**ITEM #5 - PRELIMINARY PLAT
3 JOHN'S SUBDIVISION**

KPB File No.	2024-064
Plat Committee Meeting:	July 22, 2024
Applicant / Owner:	Great Alaska Fish Camp, Inc. Poulsbo, WA
Surveyor:	Jerry Johnson / Johnson Surveying
General Location:	Sterling

STAFF REPORT

3 John's Subdivision

Preliminary Plat

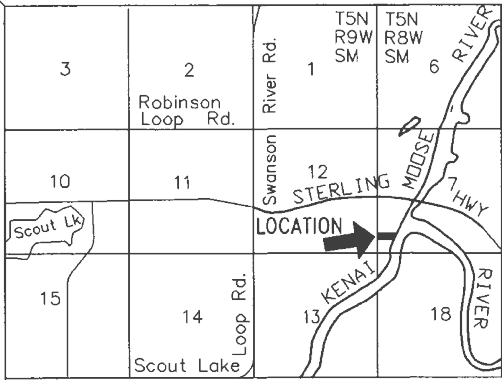
HEA REVIEWED - SEE COMMENTS

Provide a label or plat note stating, "The existing overhead powerline is the centerline of a 30-foot-wide electrical easement, including guys and anchors, granted this plat."
